FINAL DRAFT MINUTES

November 19, 2025, Standards Committee Meeting

RE: Minutes from the November 19 Standards Committee Meeting

E 715-PHCL-01 PIPE HEIGHT OF COVER LIMITS (with markups)

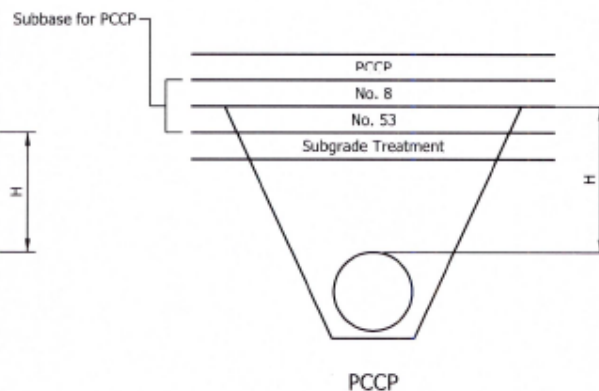
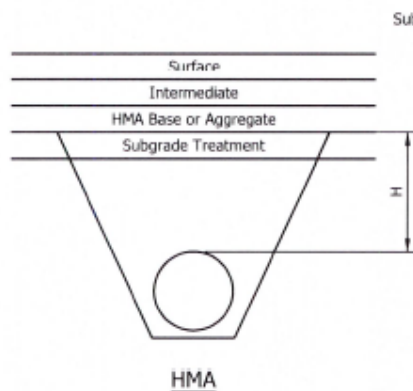
Mr. Reilman proposed to delete the pipe material types that do not have any suppliers listed on the qualified products list, and incorporate the proposed changes shown to clarify pipe material types acceptable for specified applications, add a reference to require ASTM C913 for inlets and catch basins, edit and clarify the manufacturer requirements in the table in 907.16, cascade these edits to the applicable sections following 907.16, and update the liner pipe sections.

STANDARD DRAWING NO. E 715-PHCL-01

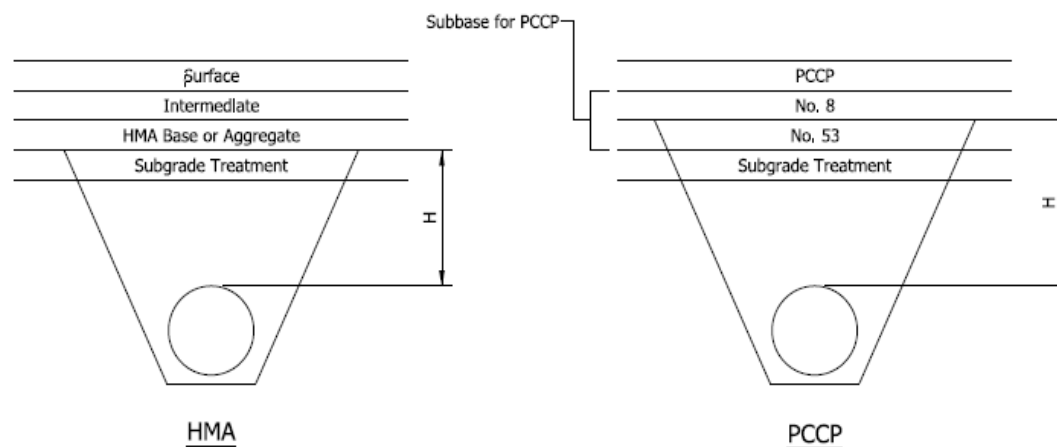
1. The tabulated cover depth H shall be measured from the top of the pipe to the bottom of the drainage No. 8 layer for PCCP and from the top of the pipe to the top of the subgrade treatment for HMA pavement.
